RE: Interim Remedial Measure Revised Design and Performance Monitoring;  
Response to New York State Department of Environmental Conservation Letter  
of November 26, 1991

RE: Frontier Chemical Waste Process, Inc.  
Response to NYSDEC Comments to Letter  
Dated November 26, 1991

# **INTERIM REMEDIAL MEASURE REPORT**

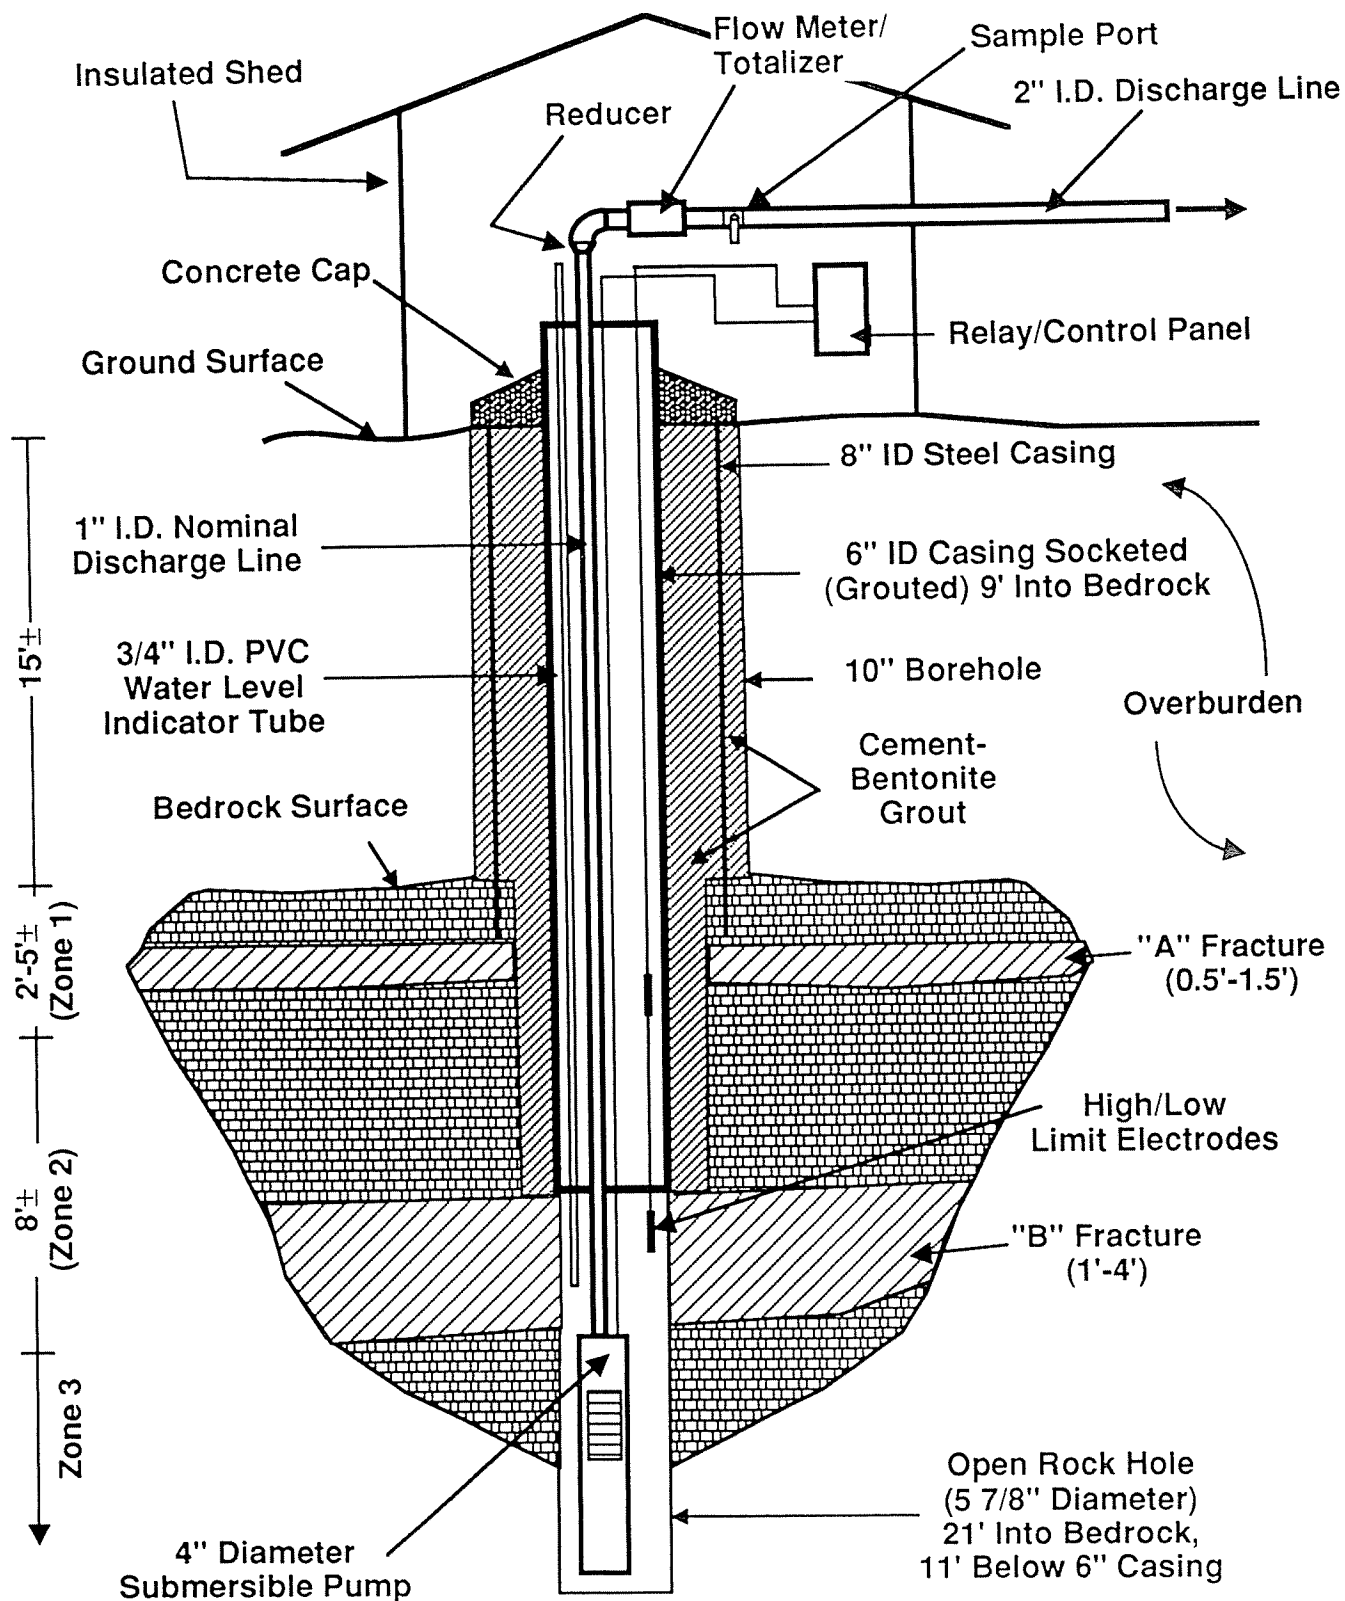
"Figure 2 has some discrepancies. The Open Rock Hole is shown to be 15' into bedrock, although it should be 21' into bedrock according to the work plan."

Figure 2 of the IRM Design and Performance Monitoring Report has been corrected to indicate the depth of the open rock hole as 21 feet.

FIGURE 3

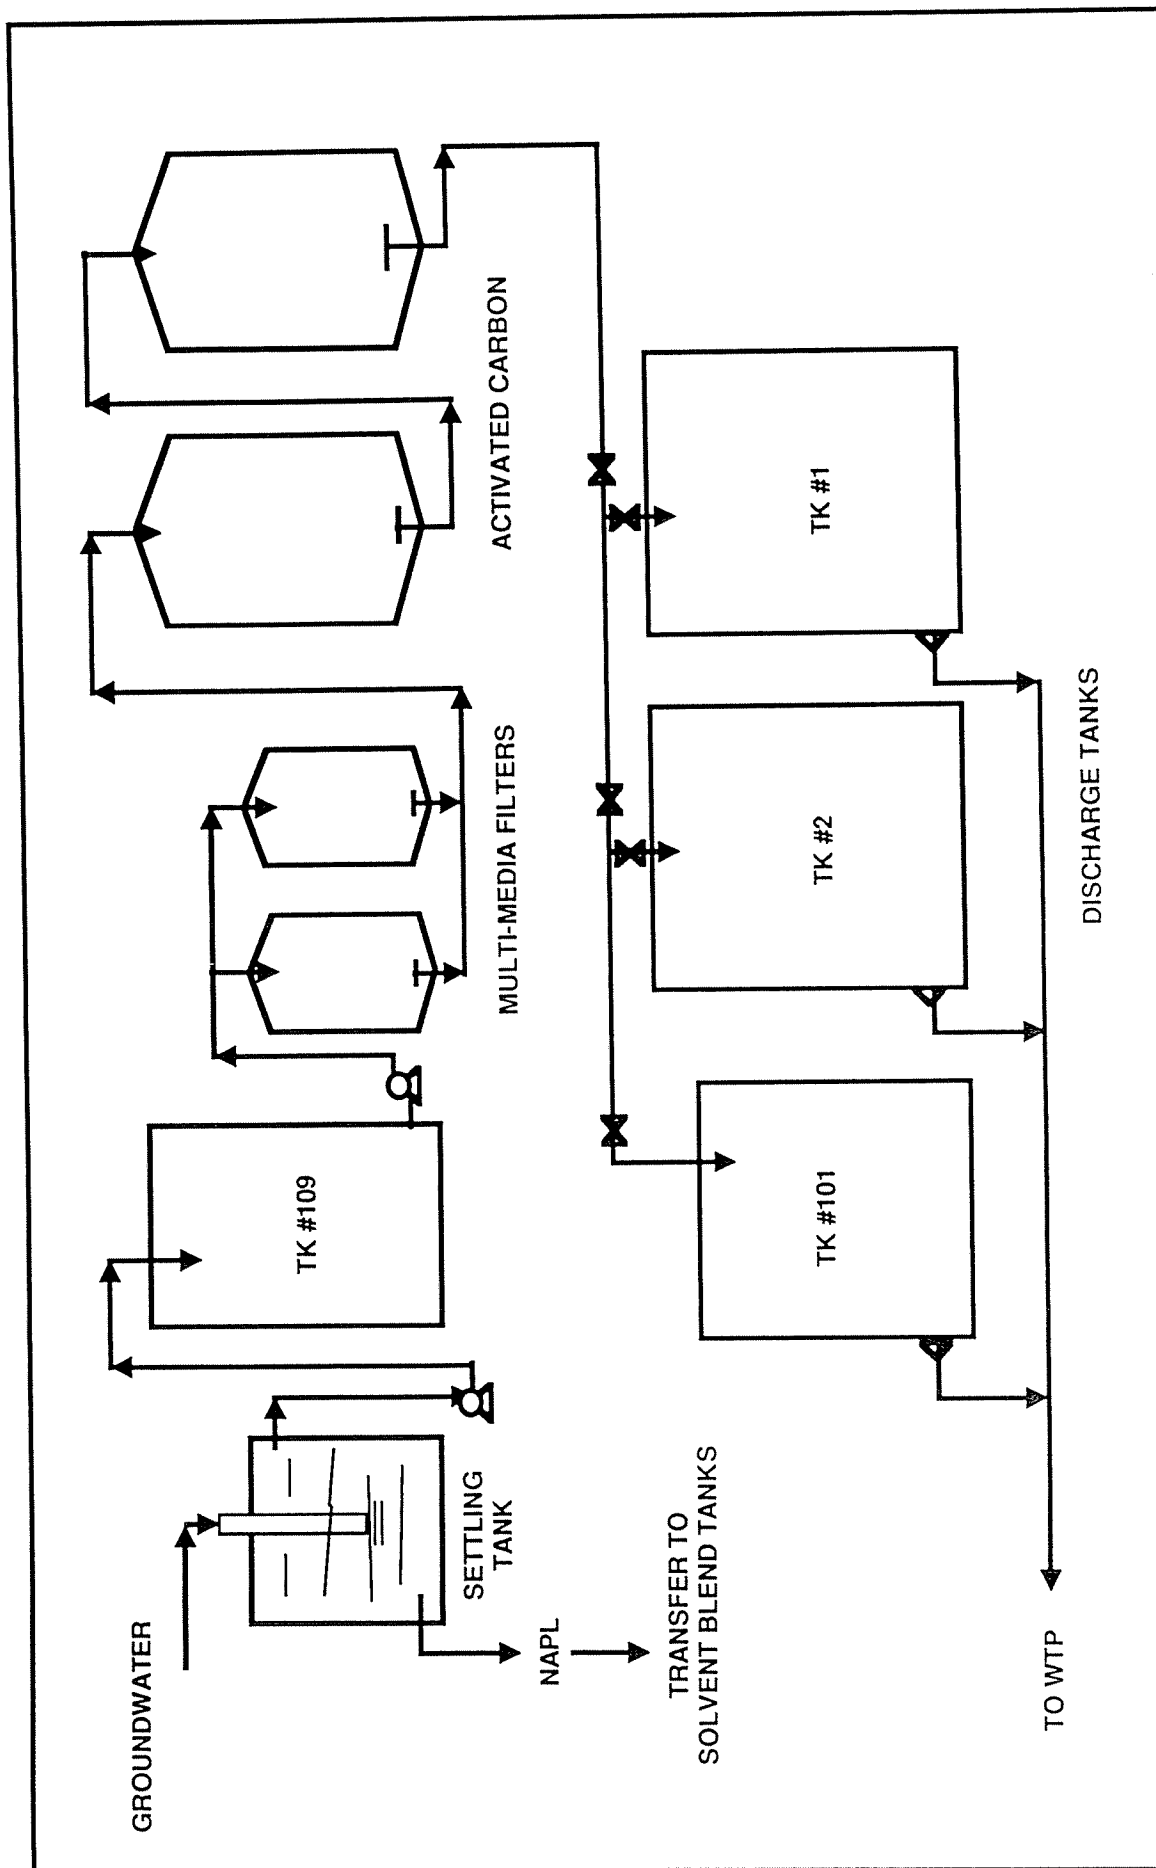
Figure 3 - All tanks must be numbered with numbers from the Part 373 Permit Application. What will be done with the sludge from the multimedia filters and the activated carbon tanks?"

Identification numbers for the replacement tanks will use numbers from the Part 373 Permit Application.
